SERVICE BULLETIN

CHECKING OF MAGNETIC PLUG

ON ROTAX® ENGINE TYPE 912/914 (SERIES)

SB-912-051

fig. 1

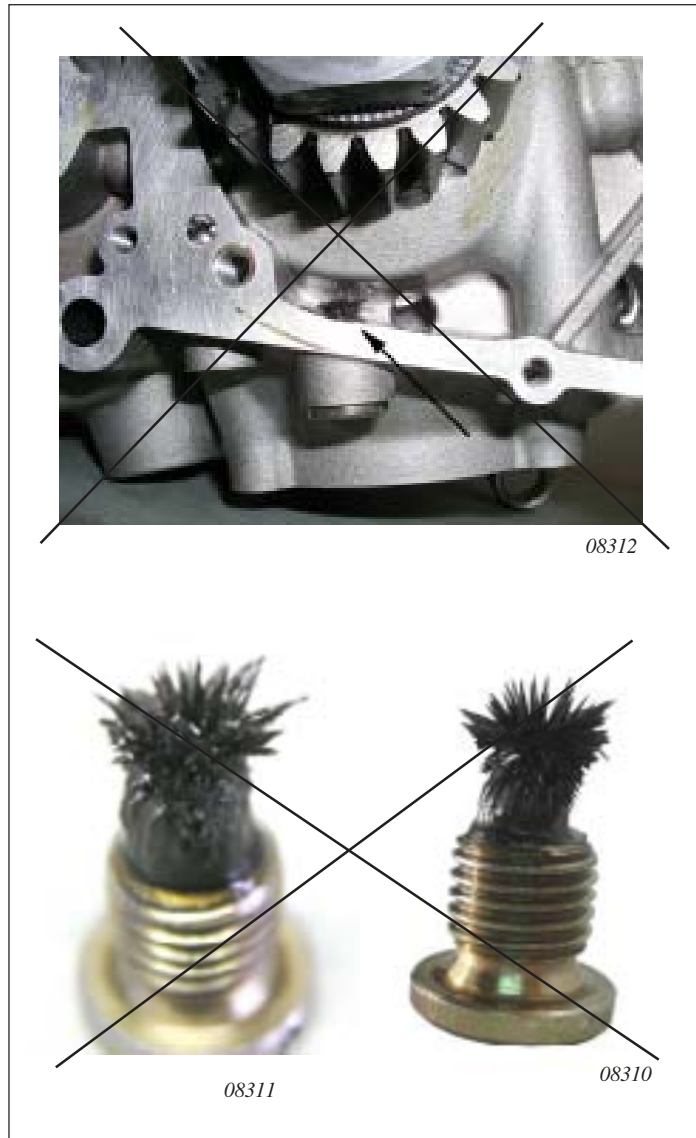
See fig. 1 and fig. 2

1. Remove the magnetic plug according to relevant Maintenance Manual.

2. Inspect magnetic plug in accordance with procedure in relevant Maintenance Manual.

■ **CAUTION:** If a greater quantity of metal particles (more than 3 mm (1/8")) is detected, consultation of an authorized distributor regarding further action is necessary. The engine must not be taken into operation until the cause has been identified and eliminated.
